Ruhe Subdivision

Minor Plan 2013-201

Memorandum

SUBJECT: Ruhe Subdivision
Minor Plan 2013-201
PRELIMINARY/FINAL PLAN REVIEW

RUIHE MINOR SUBDIVISION PRELIMINARY/FINAL PLAN

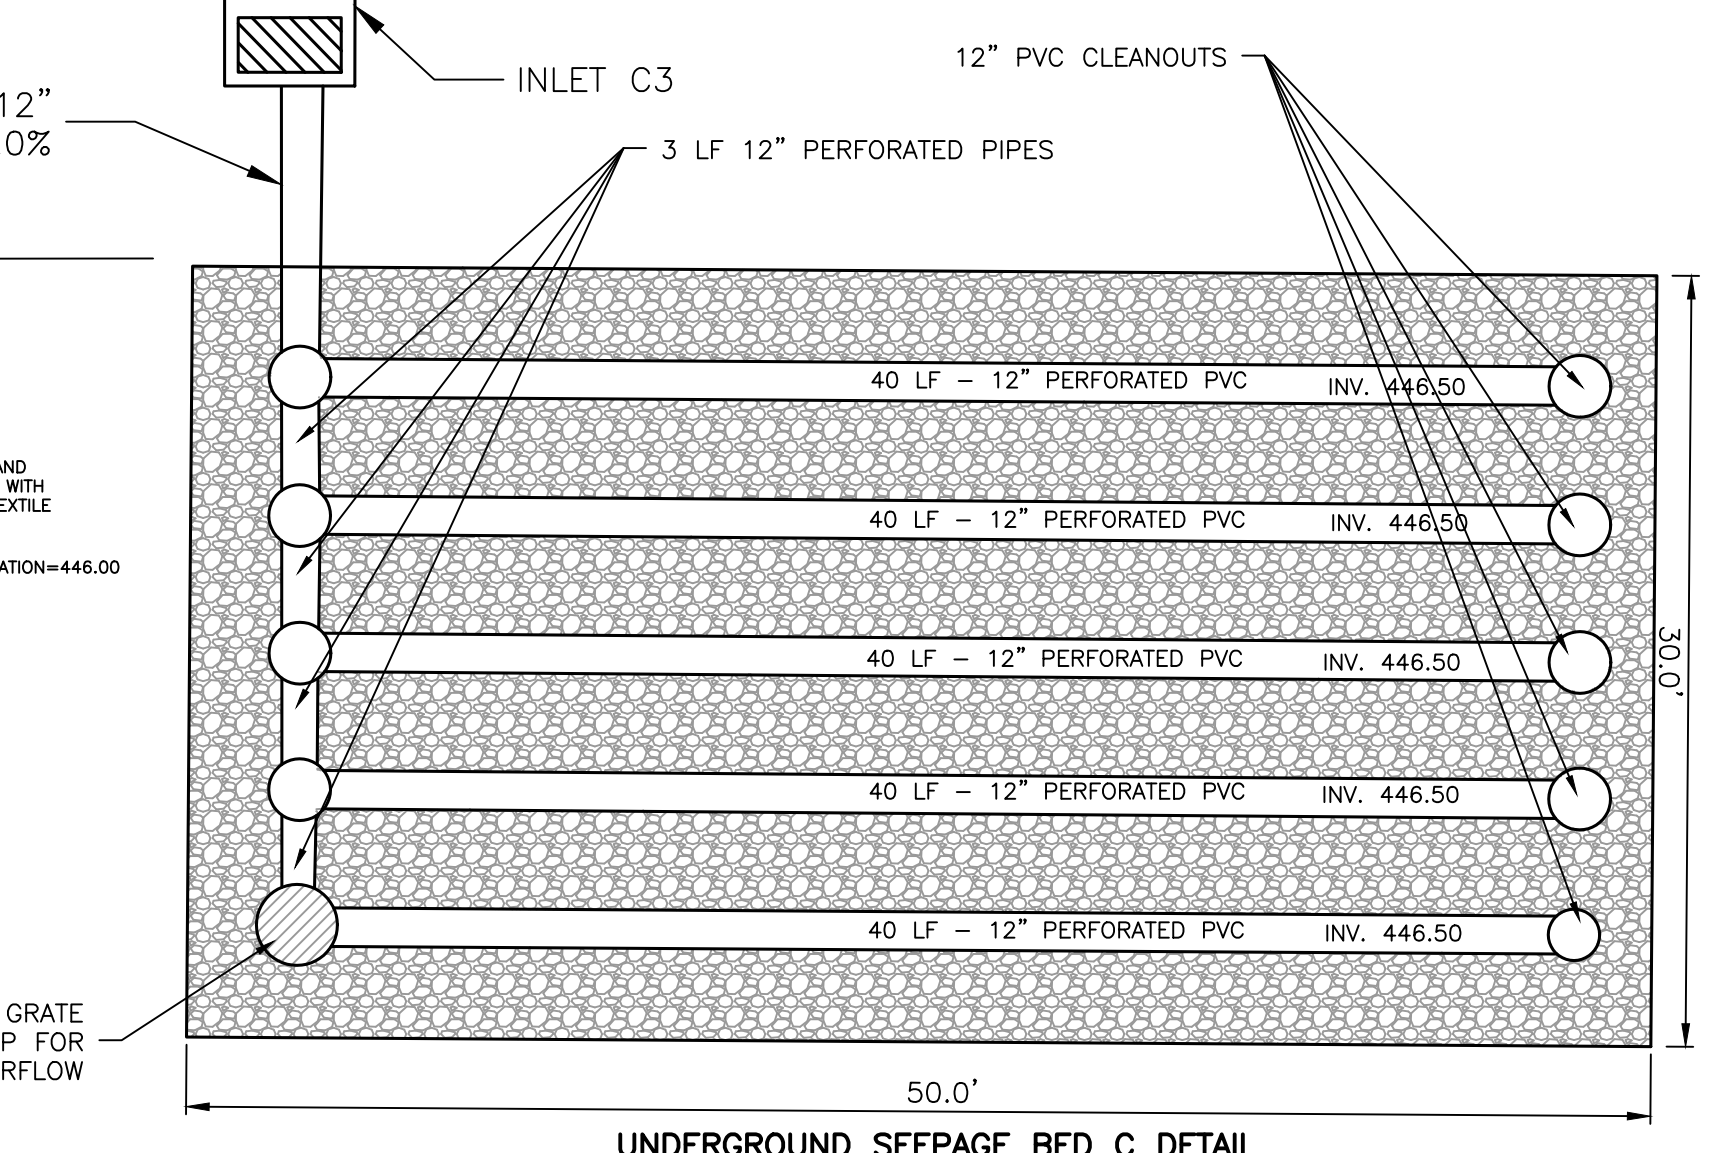
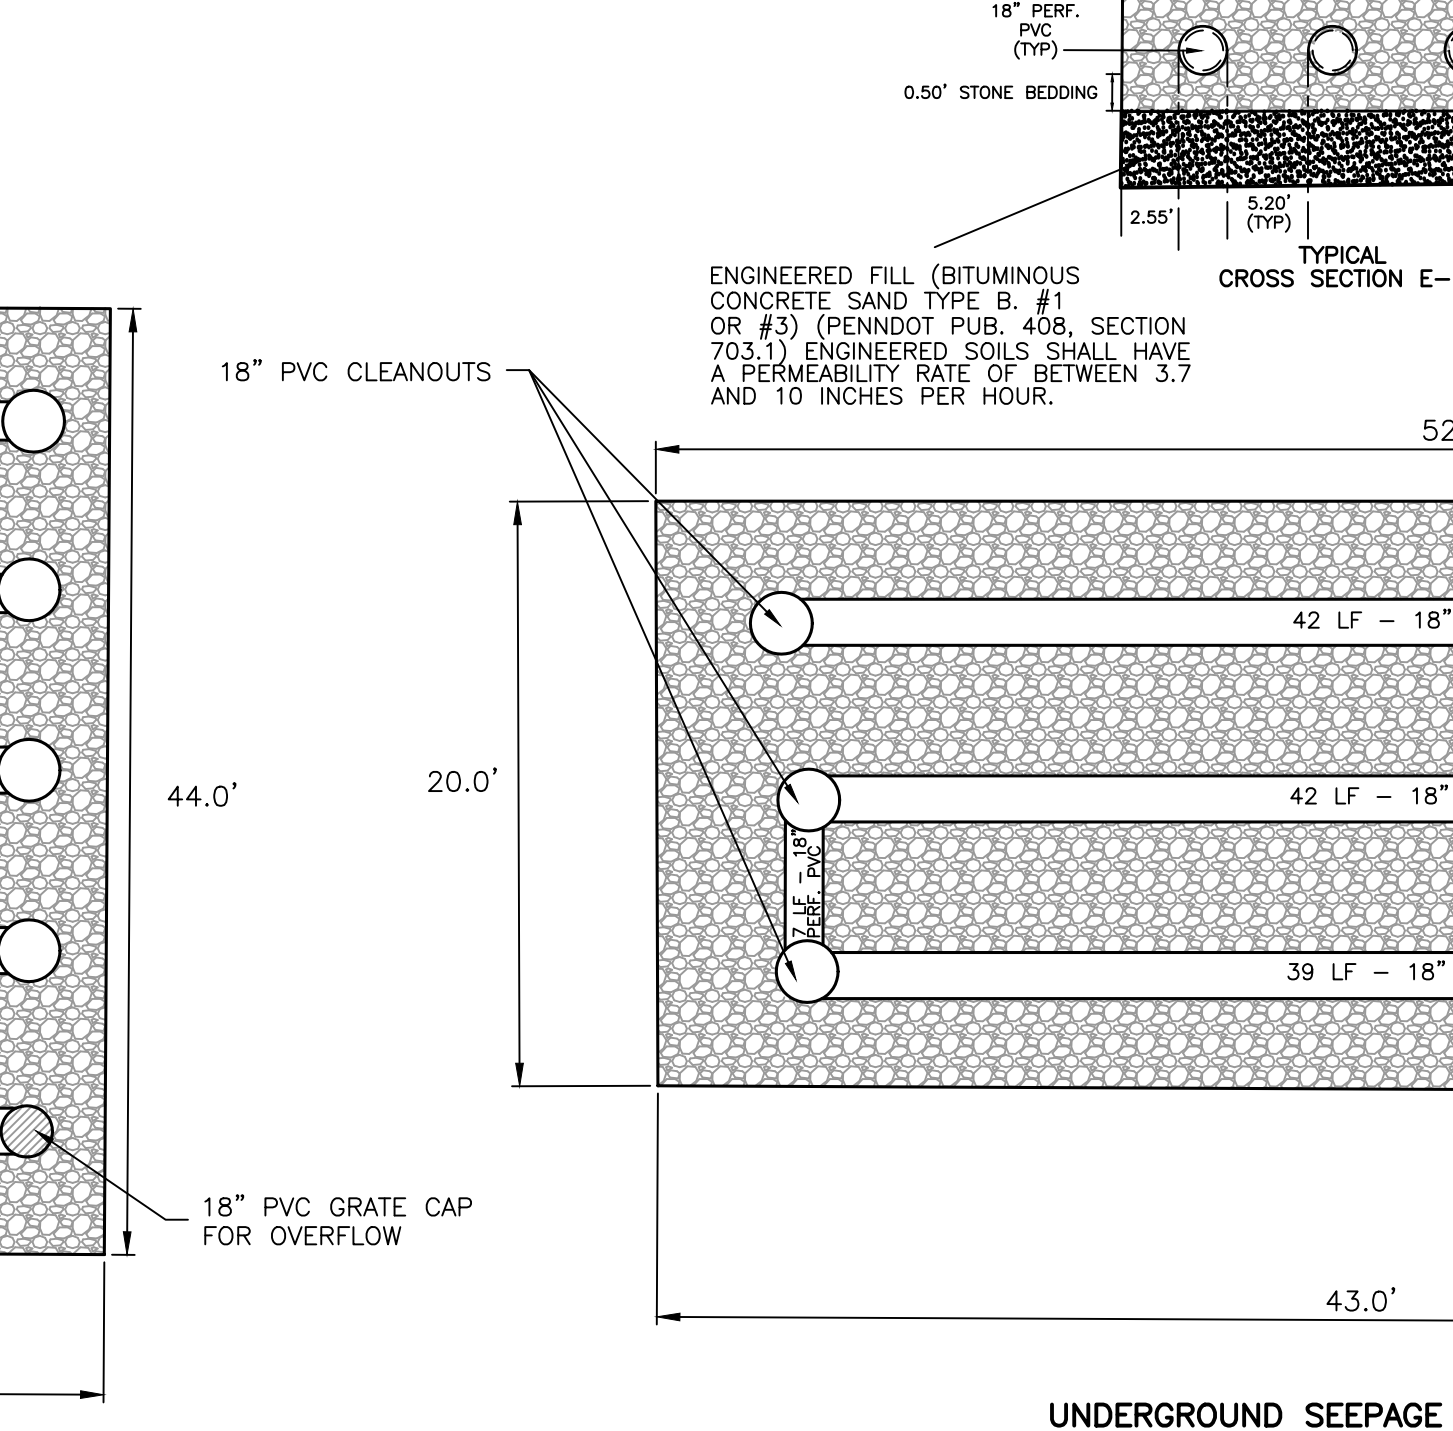
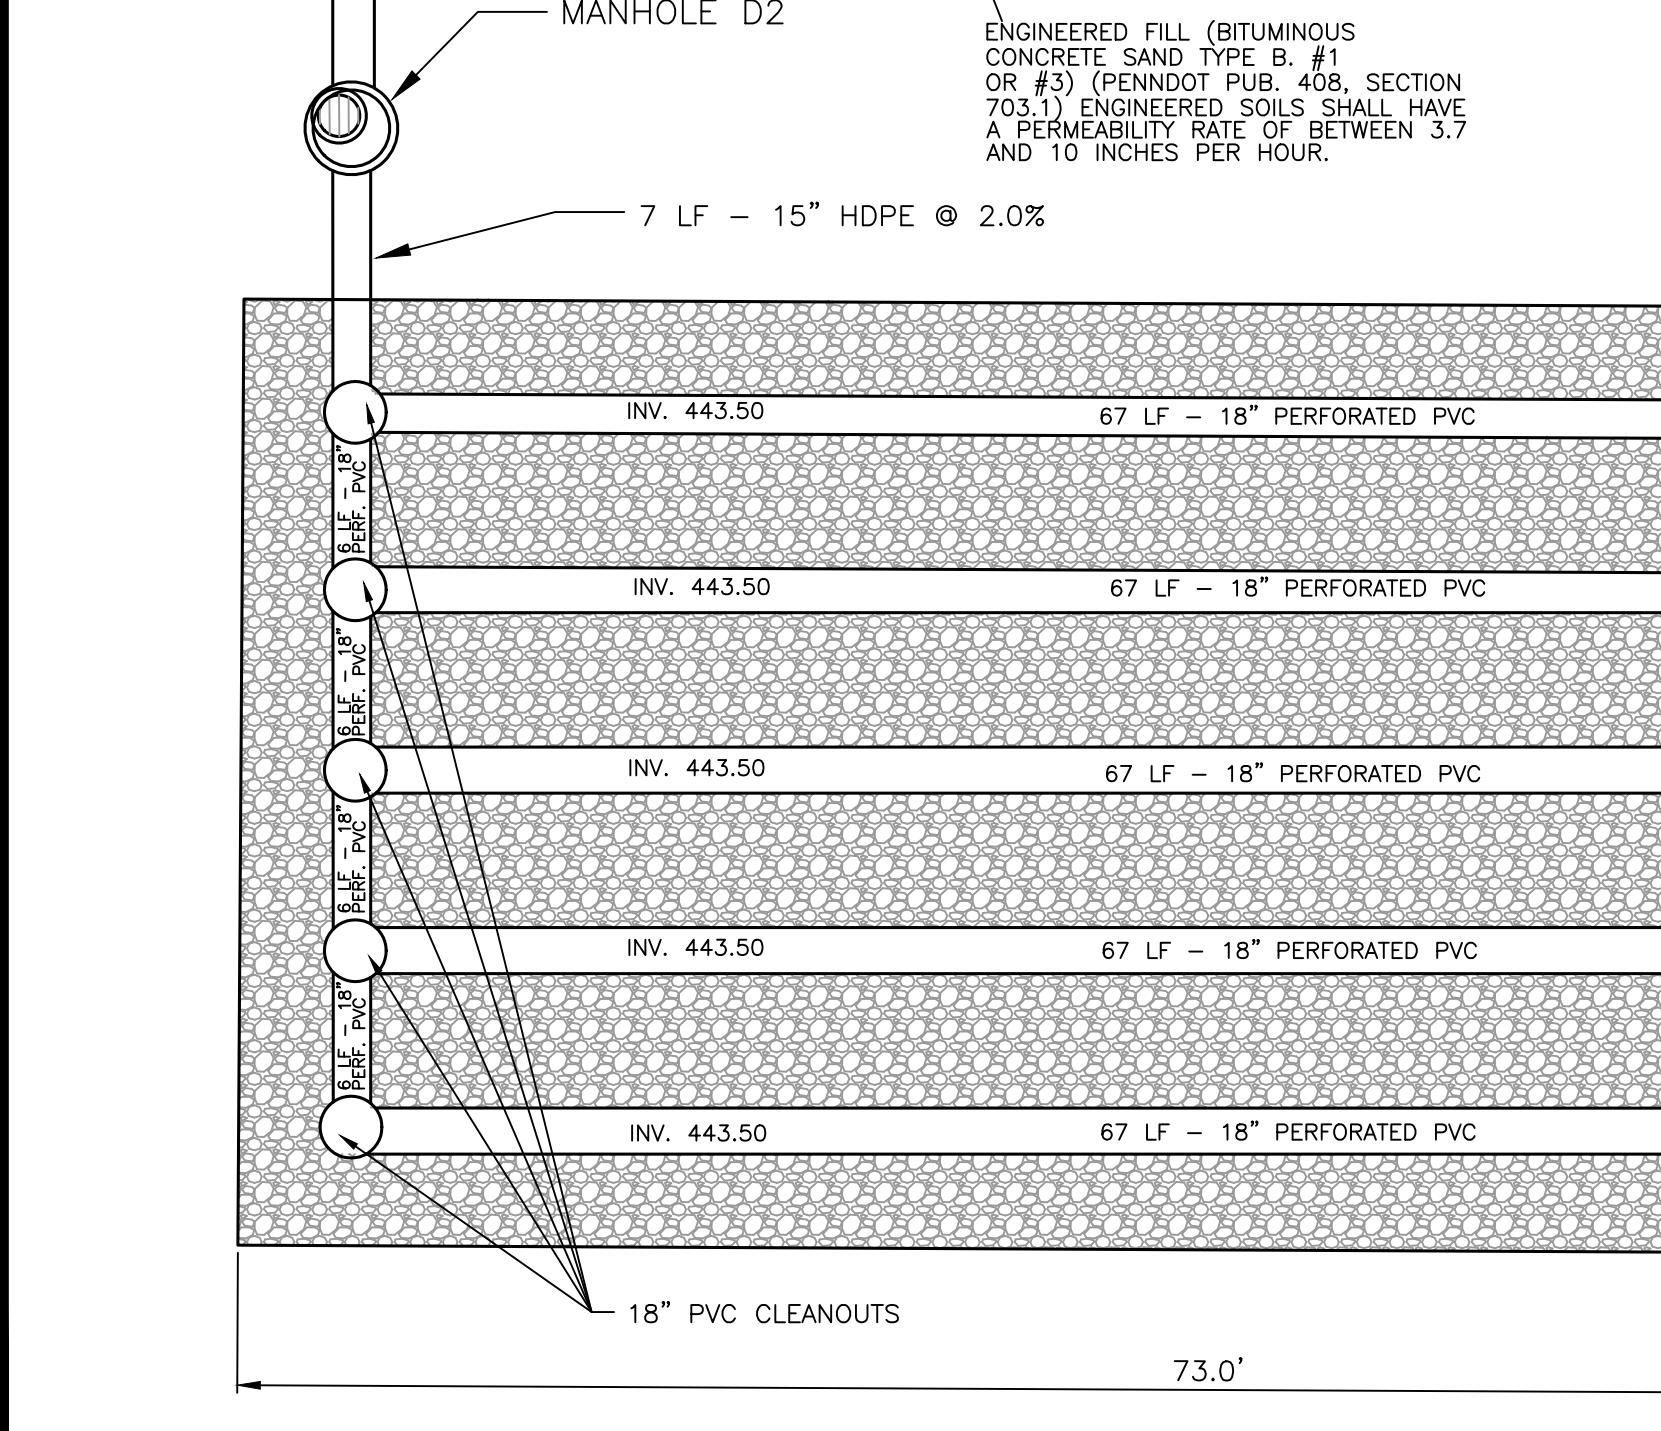
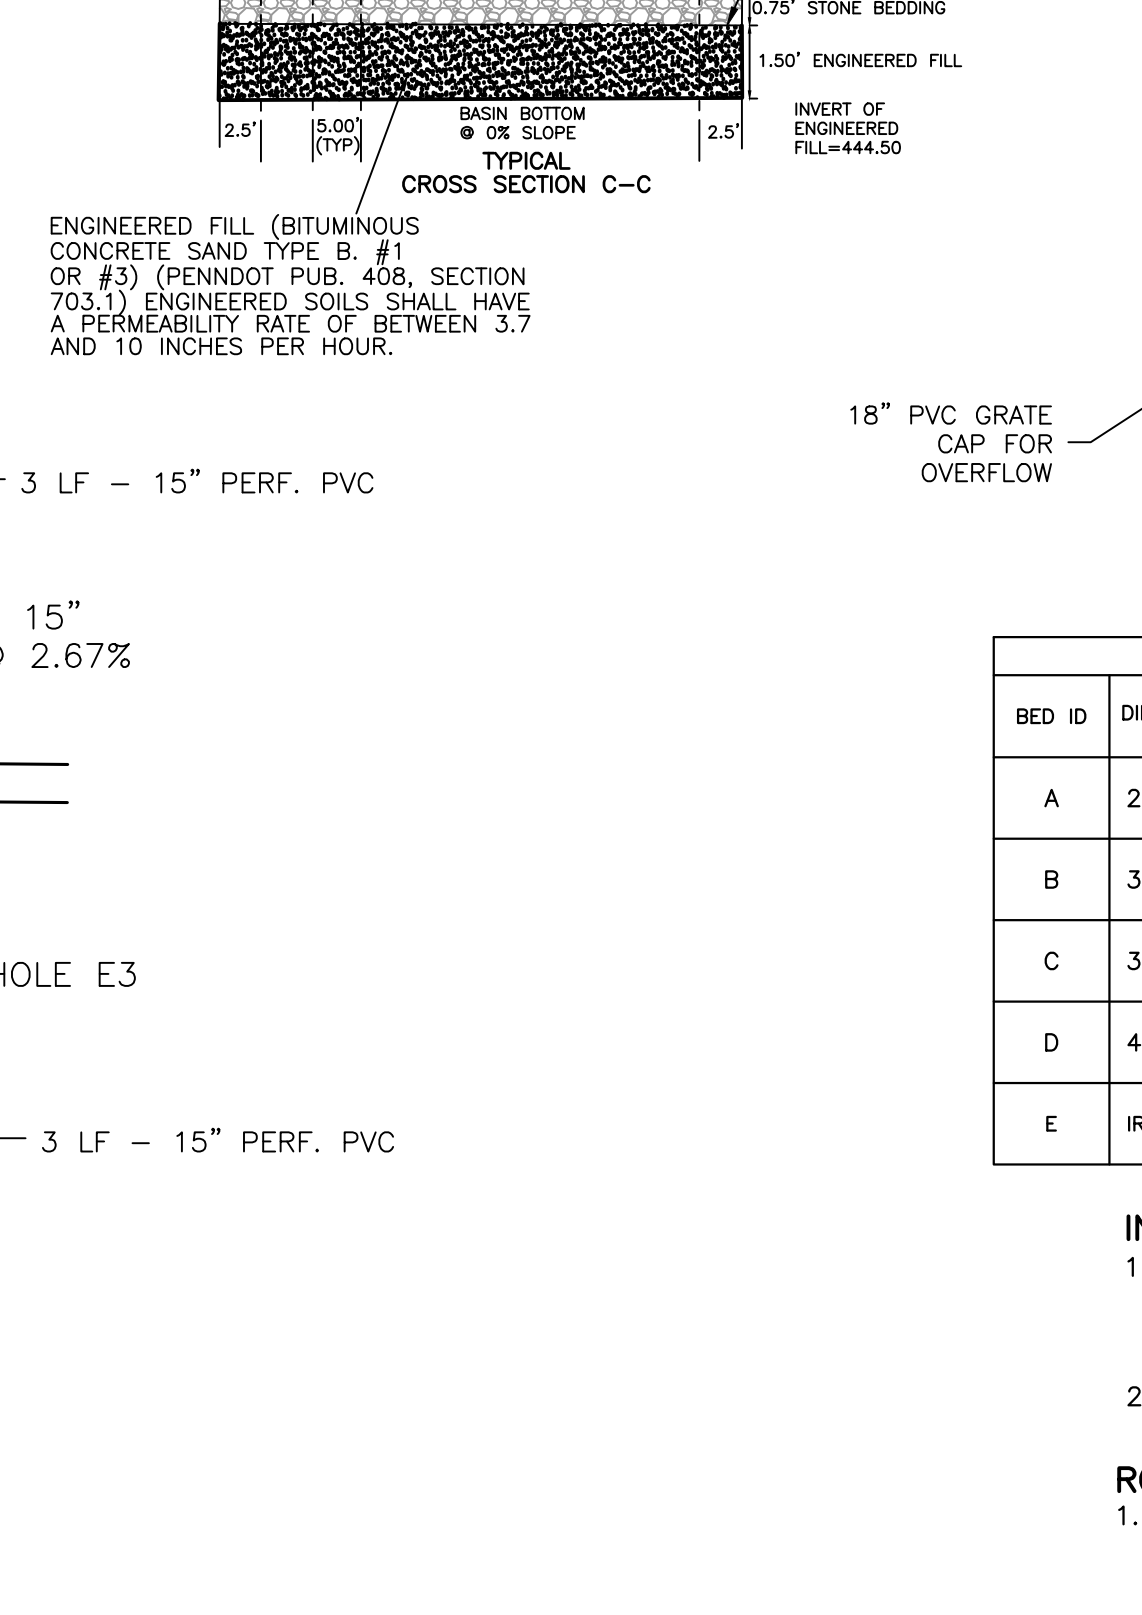
3. **Utilities Details: Sheet 16 of 23:**
